JOINT ARCHITECTURAL BOARD/PLAN COMMISSION AGENDA
MONDAY, MARCH 20, 2017
7:00 PM
BOARD ROOM
MUNICIPAL BUILDING, 210 COTTONWOOD AVE.

In regards to Ruckert & Mielke's Plan Review Letter to Benchmark Secured Storage dated February 17, 2017, the following notes in red are responses from Jahnke & Jahnke Associates, Inc. and Perspective Design, Inc., as referenced below.

PROPOSED SITE PLAN
FOR: LOT 2 CSM 9413
PART OF THE SW 1/4 OF SECTION 10, T7N, R18E
VILLAGE OF HARTLAND, WAUKESHA COUNTY, WI.

PROPOSED LANDSCAPE PLAN
FOR: LOT 2 CSM 9413
PART OF THE SW 1/4 OF SECTION 10, T7N, R18E
VILLAGE OF HARTLAND, WAUKESHA COUNTY, WI.

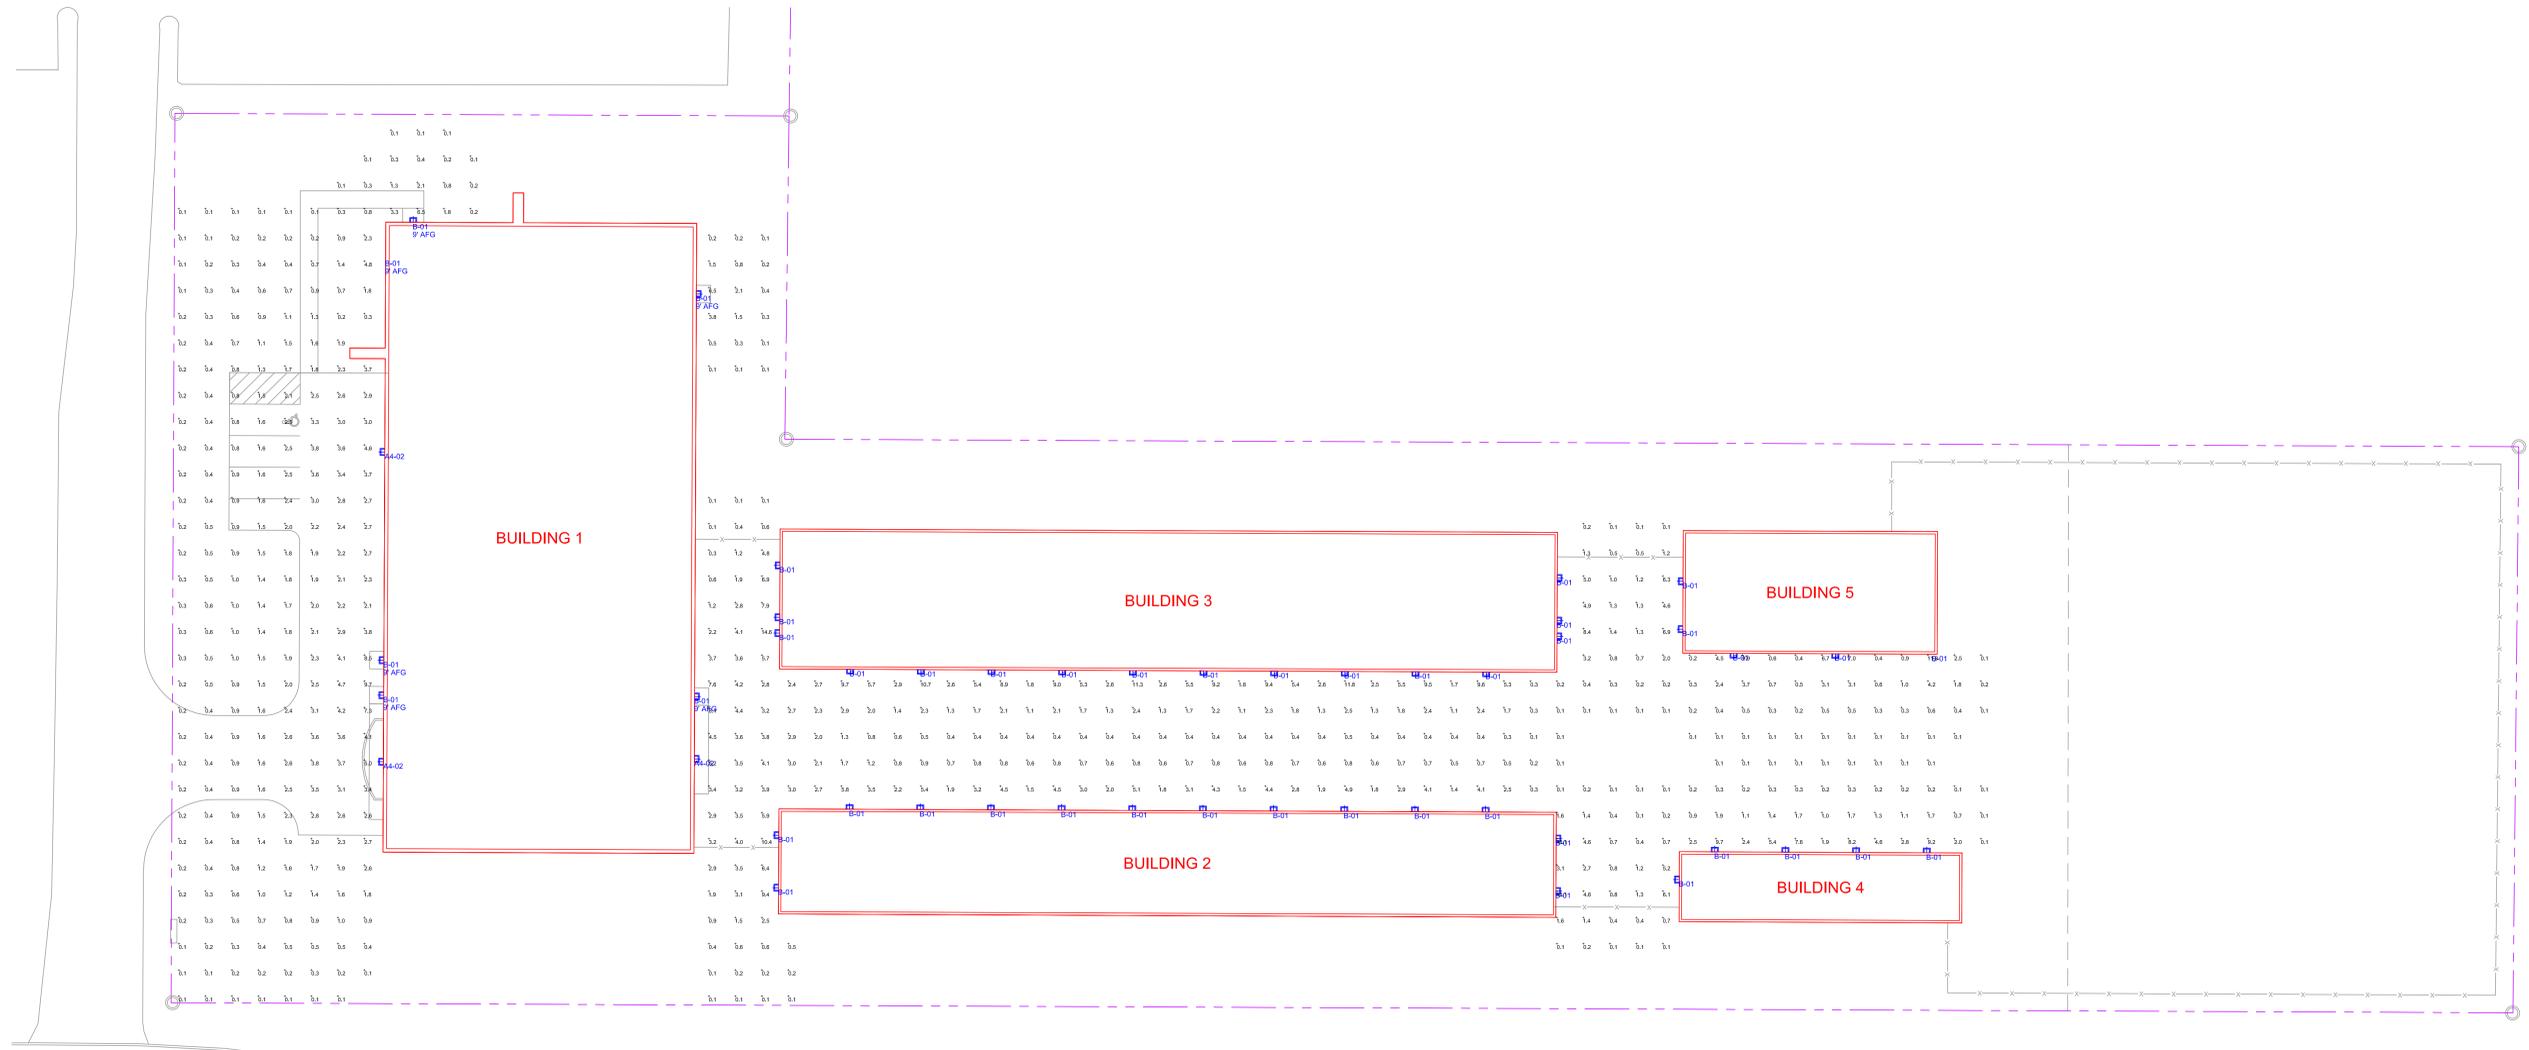
Proposed Landscape Plan

1. Show proposed swales and adjust landscaping to not conflict with drainage.

2. It appears that some of the existing trees/ shrubs along the west property line are Buckthorn. Any and/or all Buckthorn shrubbery shall be removed and replaced. Please verify and show additional plantings if necessary.

3. Provide screening to the proposed building #5.

4. Update fence note to provide for (2) 15' wide swing gates for Village entry into the site. Please update note and change the term "City" to "Village".

Per J&J response letter dated 3.7.17, swales shown.

Per J&J response letter dated 3.7.17, note added.

Per J&J response letter dated 3.7.17, building screened by existing tree line. We did add some arborvitaes to be placed in holes that may become apparent.

Per J&J response letter dated 3.7.17, gate upgraded to 15 feet.
